City of Santa Fe

REGULAR MEETING OF THE PLANNING COMMISSION OCTOBER 21, 2021 AT 6:00 PM MEETING VIRTUALLY

1. **Case #2021-4219. Monte Sereno Master Plan Amendment.** Al Lilly, Agent, for 21 Club Holdings LLC, Owner, requests Master Plan Amendment to include infrastructure and design elements for the Hotel Use. The Property is approximately 34.96 acres and zoned PRRC (Planned Residential Resort Community), located West of Highway 285, North of Tano Road at 4000 Monte Sereno Drive, and is within the Monte Sereno Development. (Dan Esquibel, Case Manager, daesquibel@santafenm.gov,505-955-6587)

2. **Case #2021-3800. Monte Sereno Development Plan.** Al Lilly, Agent, for 21 Club Holdings LLC, Owner, requests development plan approval to construct 170,000 square feet of new construction for hotel use. The Property is approximately 34.96 acres and zoned PRRC, located West of Highway 285, North of Tano Road at 4000 Monte Sereno Drive, and is within the Monte Sereno Development. (Dan Esquibel, Case Manager, daesquibel@santafenm.gov,505-955-6587)

DATE:	SCALE:	SHEET:
JUNE 2021	1" = 60'	C-301

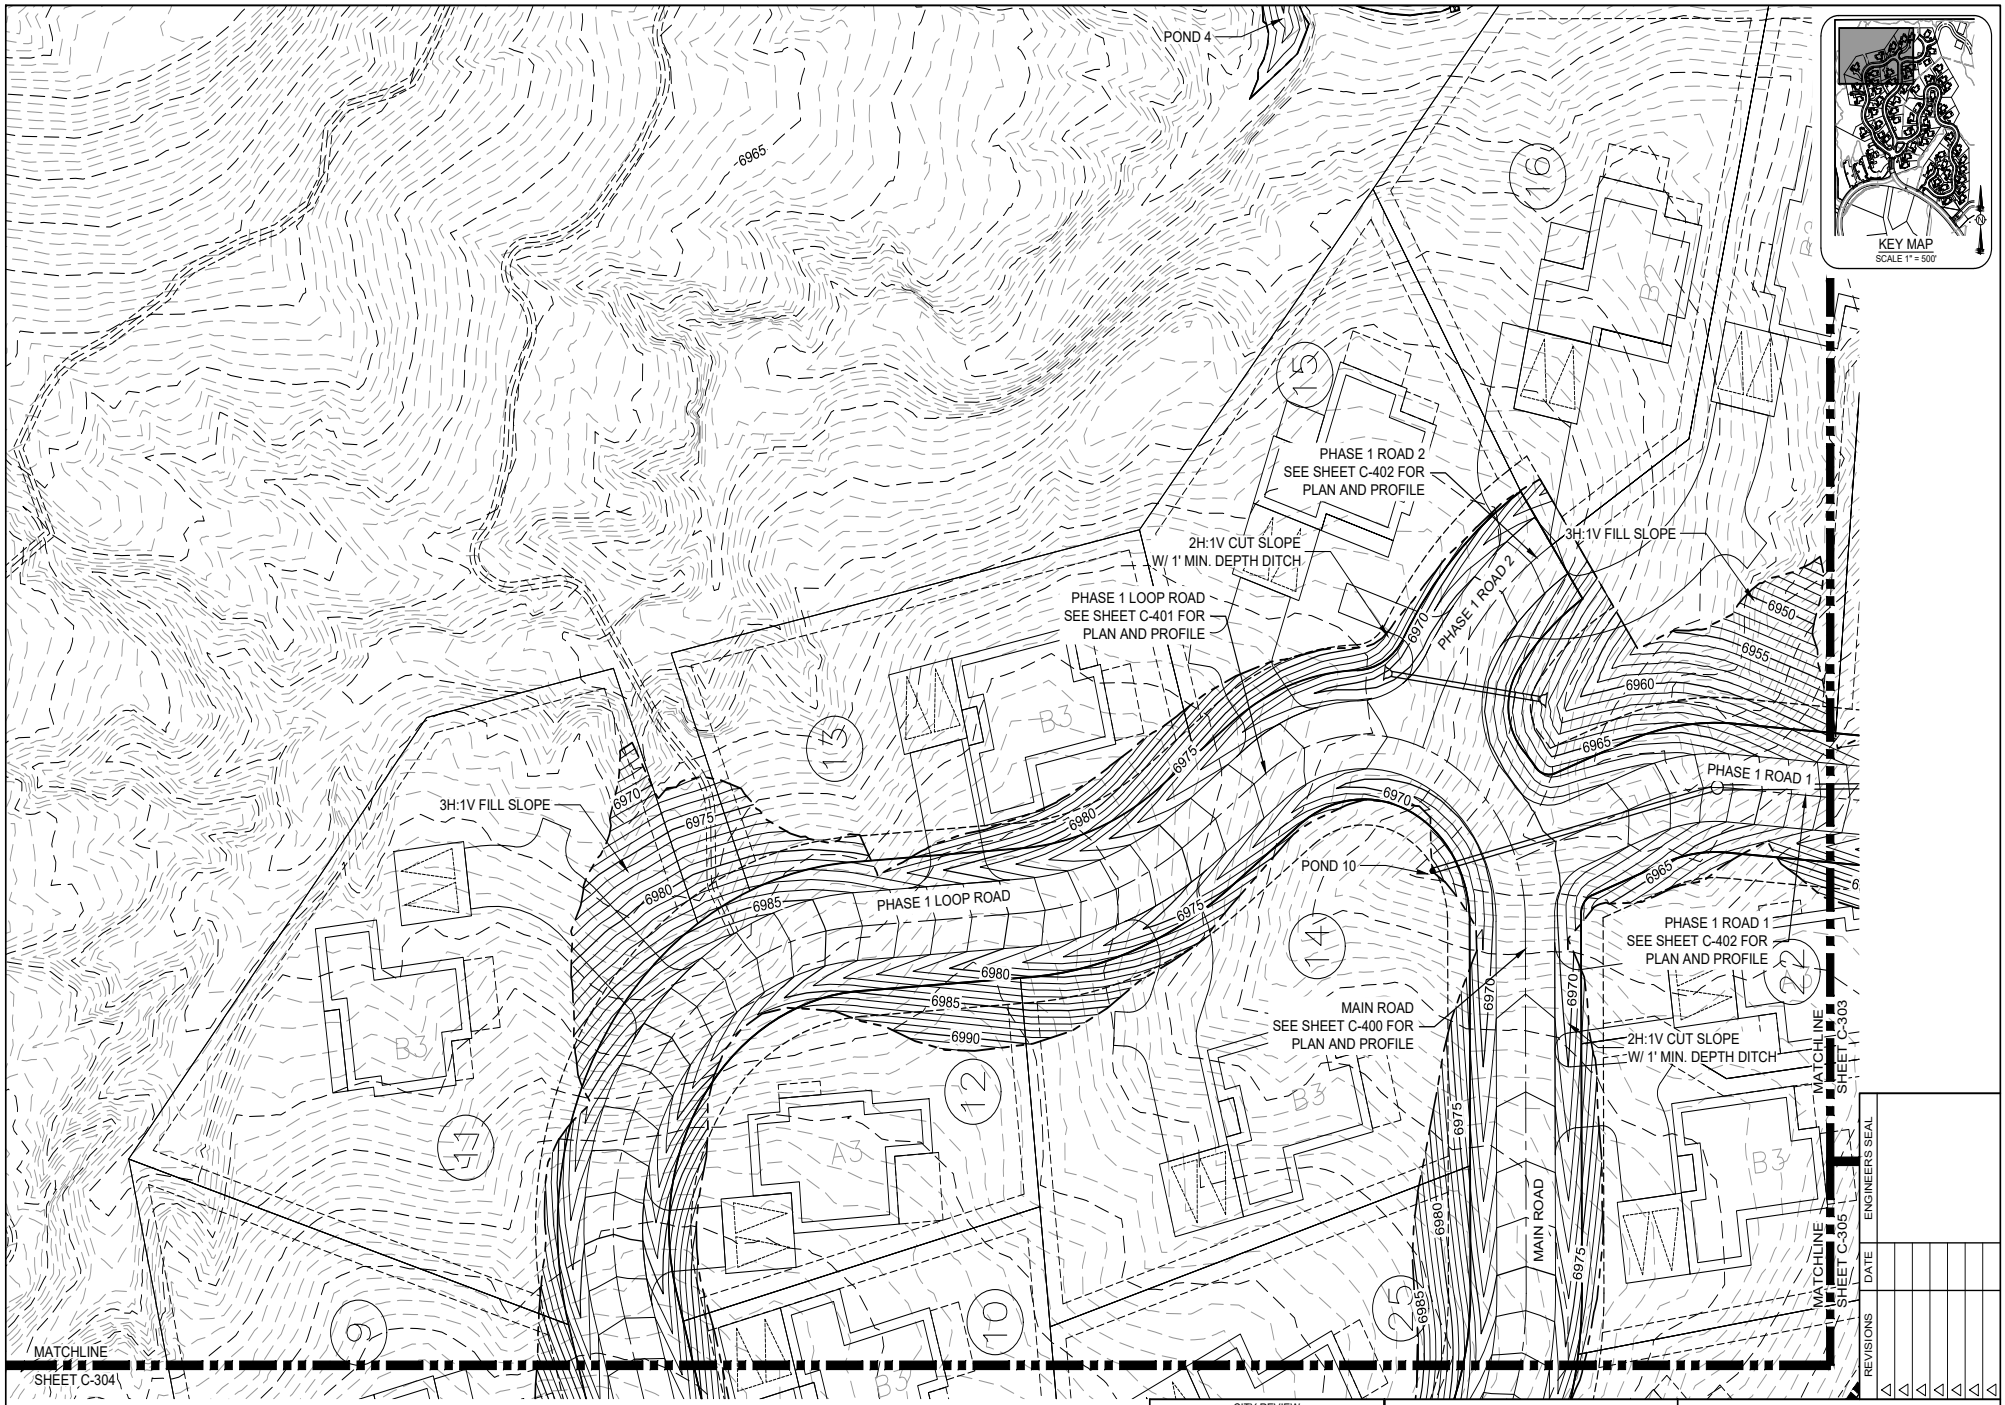
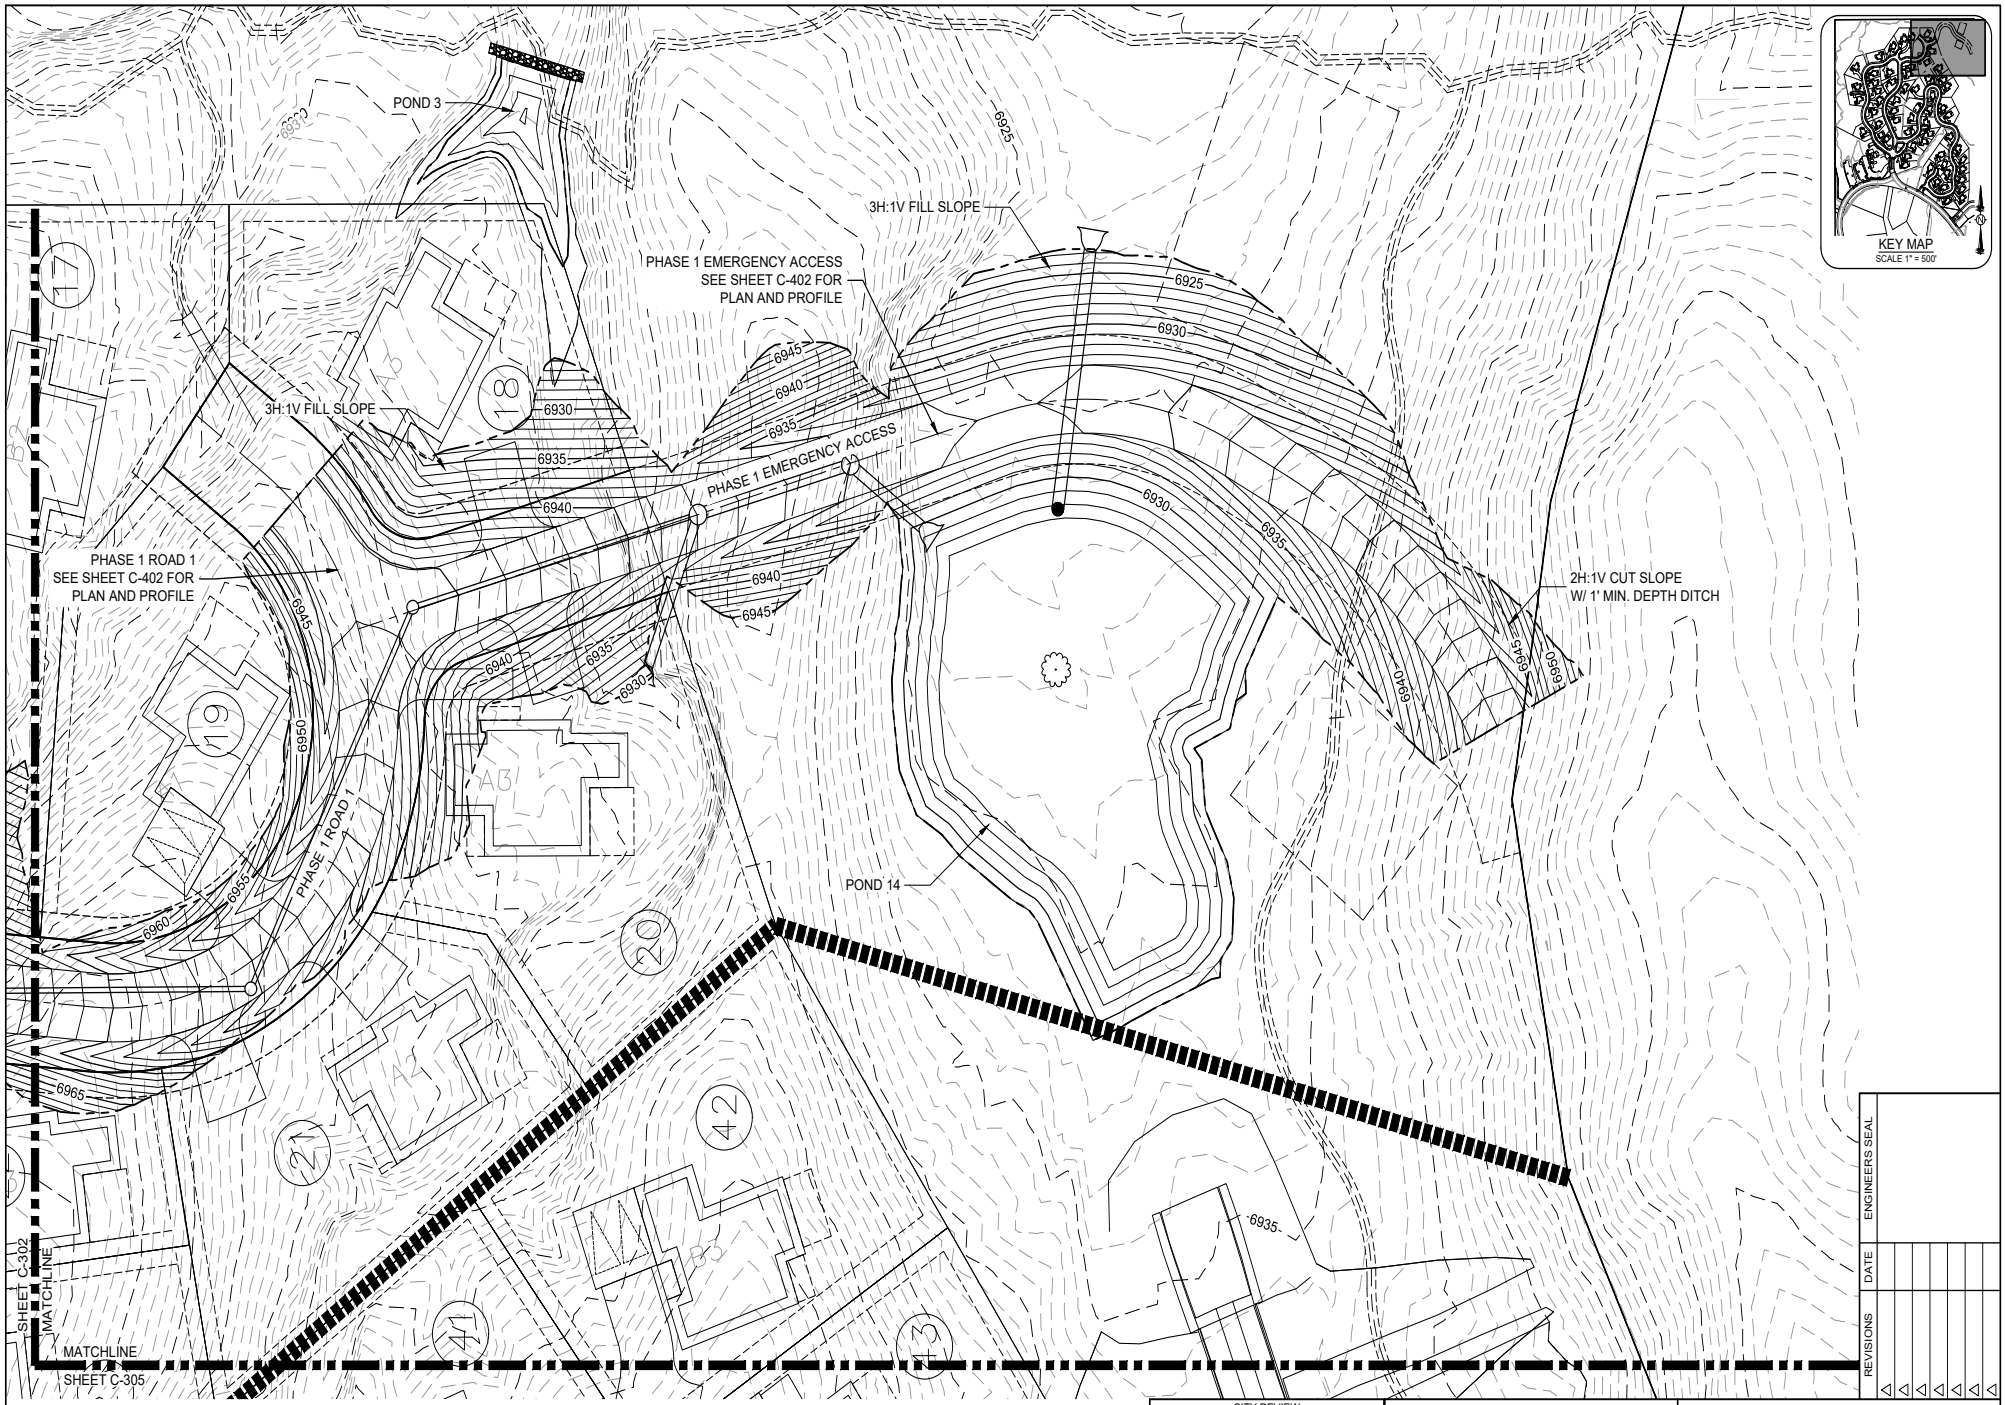
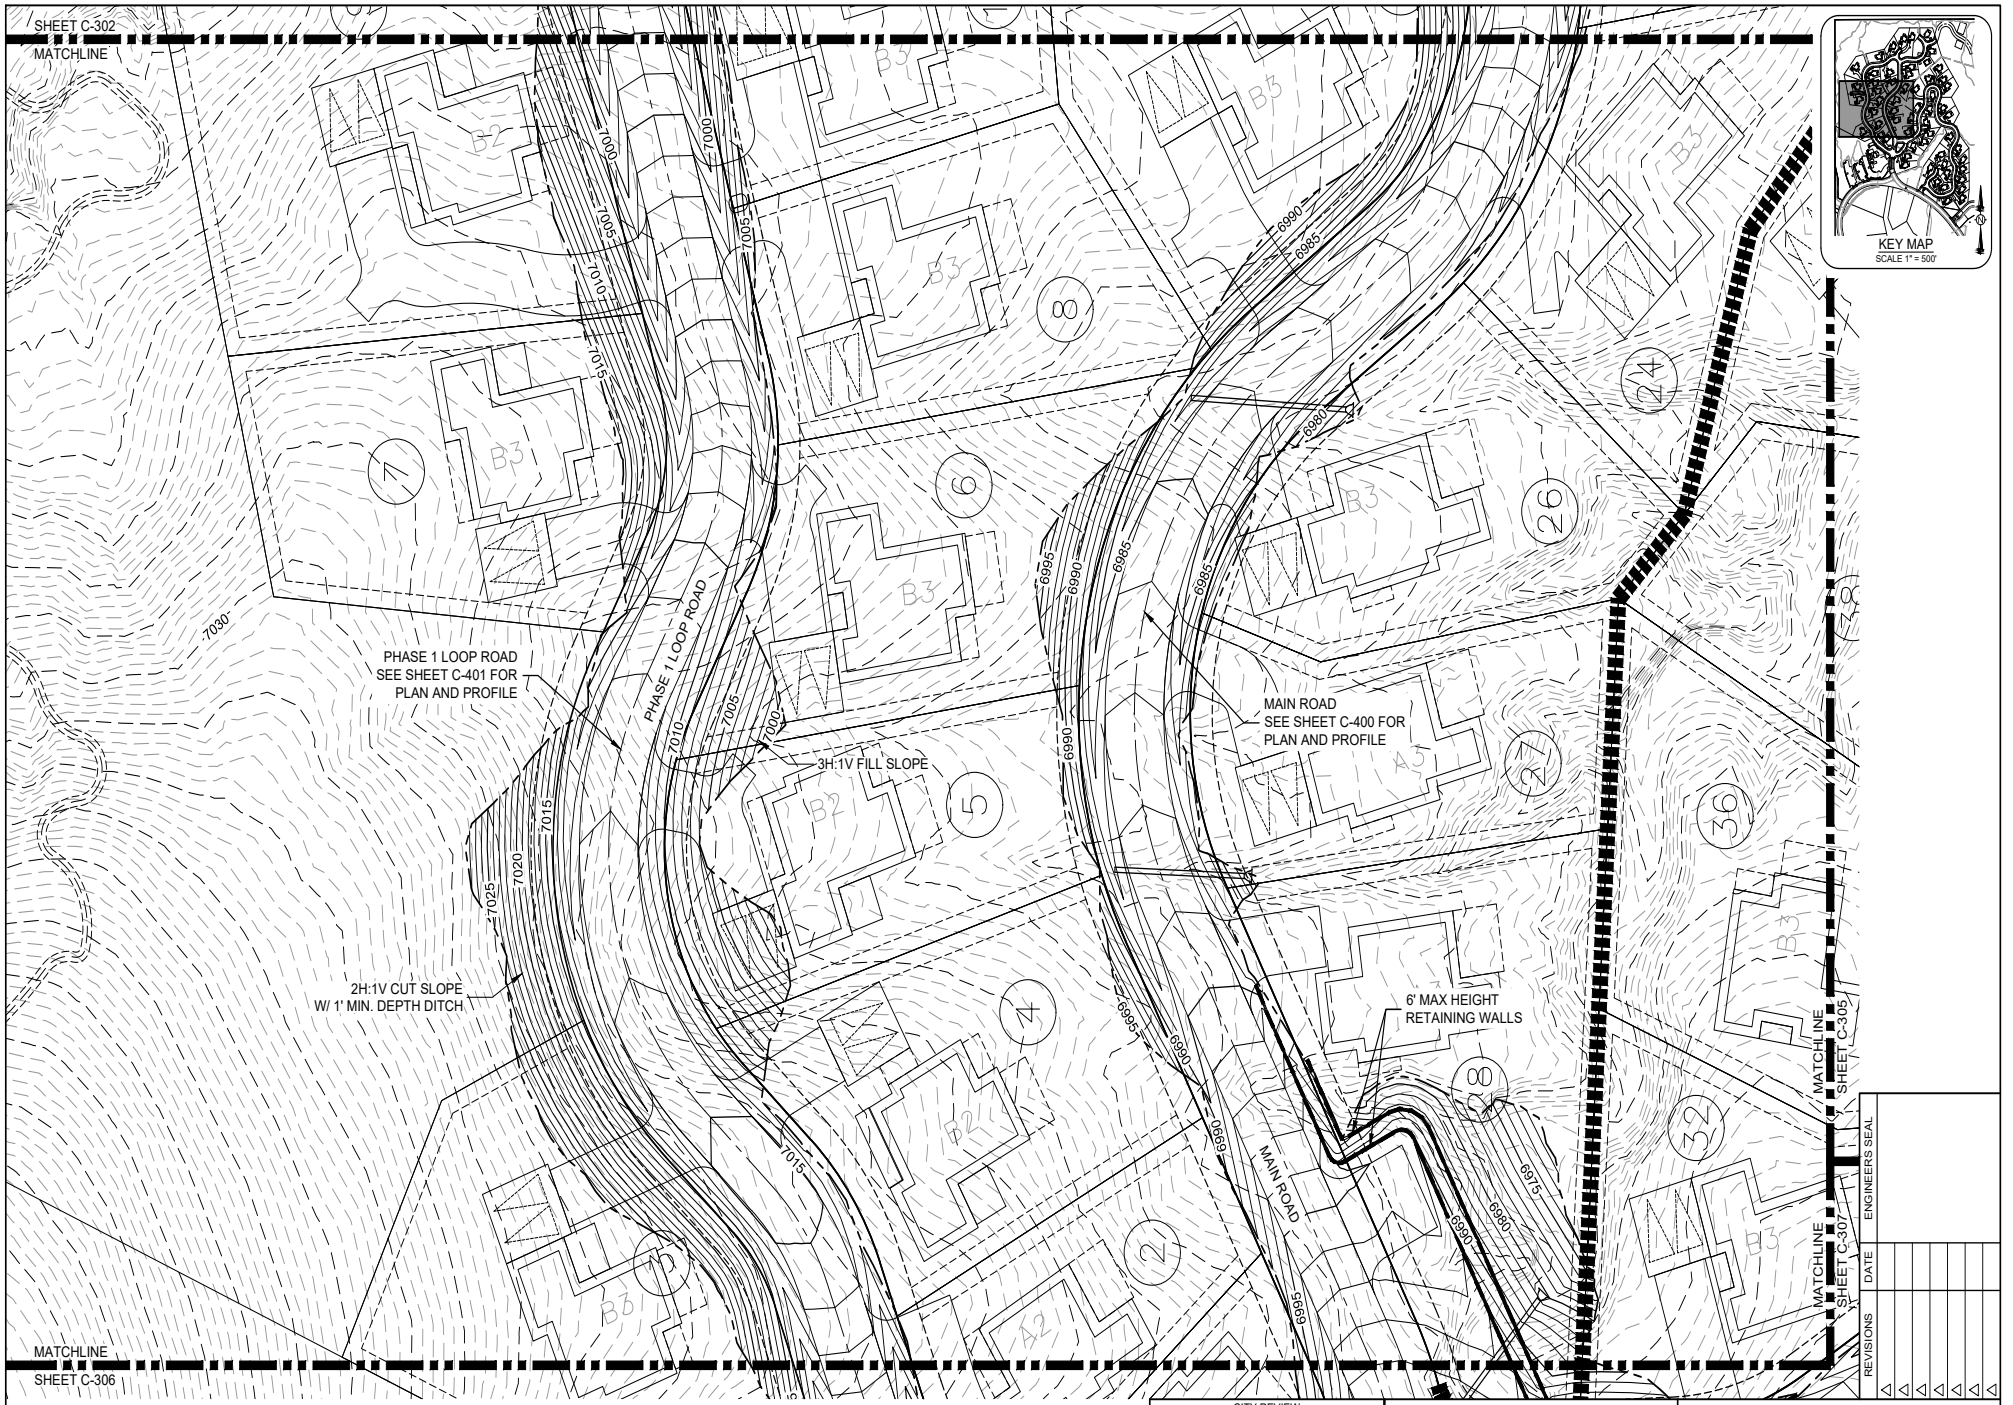
11. Sheet C-301. Label proposed curb and gutter, storm sewer manholes and culverts. Provide detail/section of each pond.
12. Sheet C-302 through sheet C-308. Label existing contour elevations, storm sewer manholes and CMP's. Indicate grading limits and location of utility easement.
